BULLETIN.017

WELDARC 140: MC84 WELDARC 12P: MC85
MC84-11 TRIAC PCB

WELDING INDUSTRIES OF AUSTRALIA	
				112 Daws Road, Melrose Park. S.A.5039	
				TITLE	
				P.C.BOARD ASSEMBLY	
B	10/7/90	gc	RESISTOR VALUES R8 & R9 CHANGED C/N 1054	DRAWN	DRAWING No.
A			ISSUE FOR MANUFACTURE	M.W.	
ISSUE	DATE	CHKD.	REVISION	DATE	
				6-7-90	MC84-11

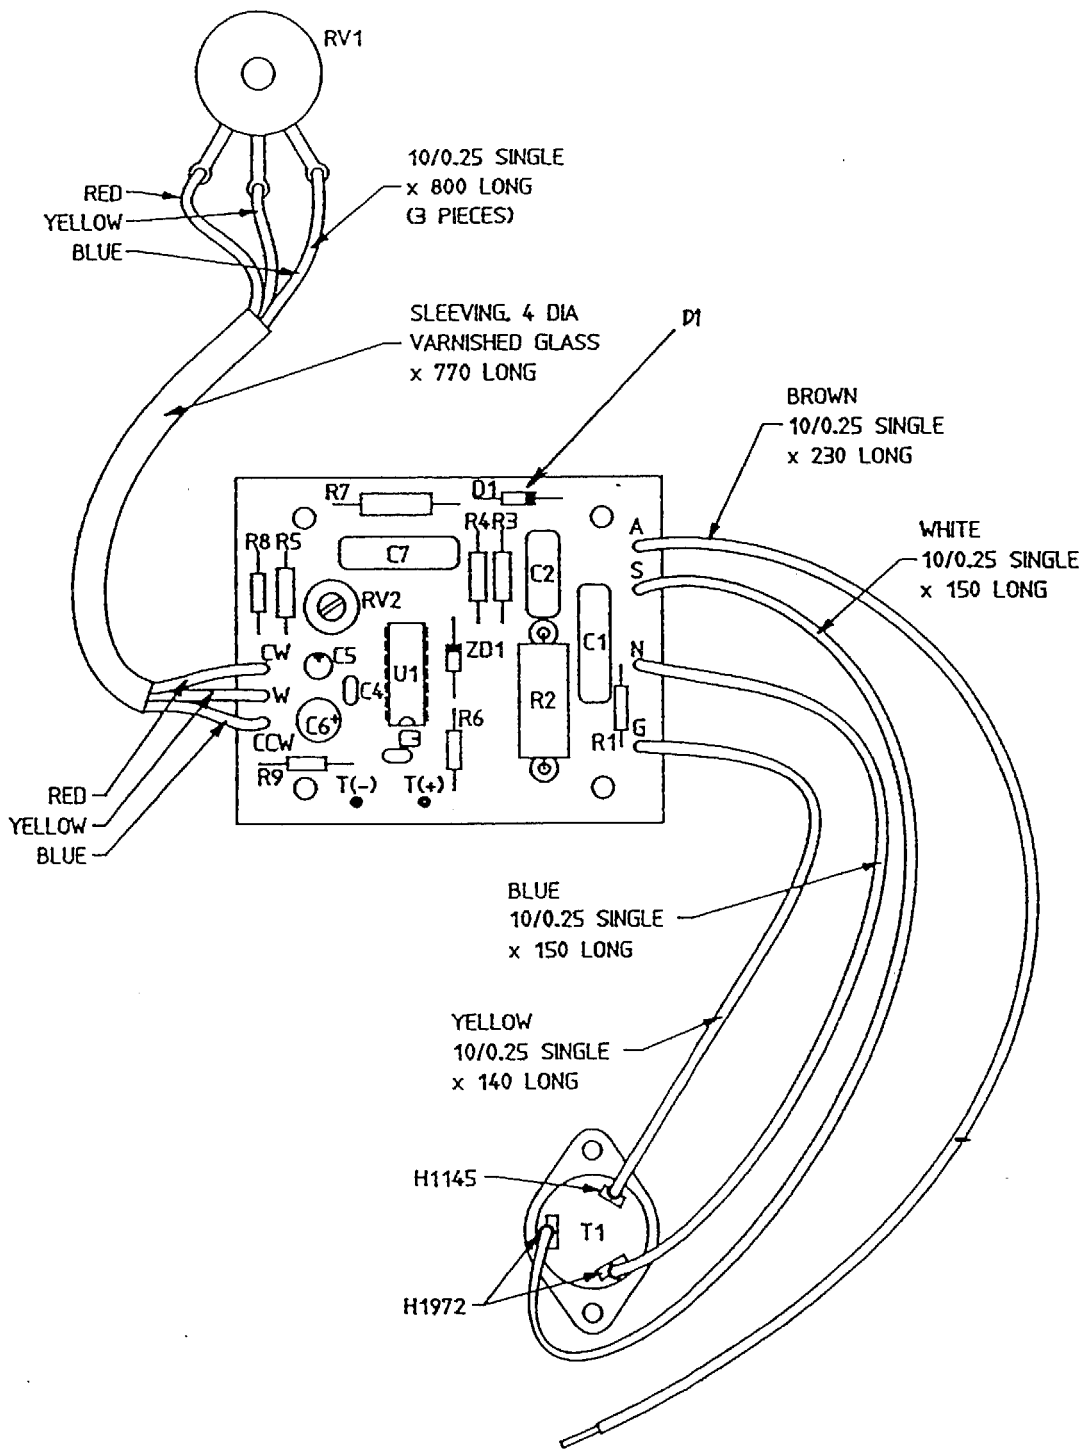
Diode D1 has now been changed from CP101-11/10 (1N4007) to a MC84-11/3 (BYW56).

Refer to attached component overlay.
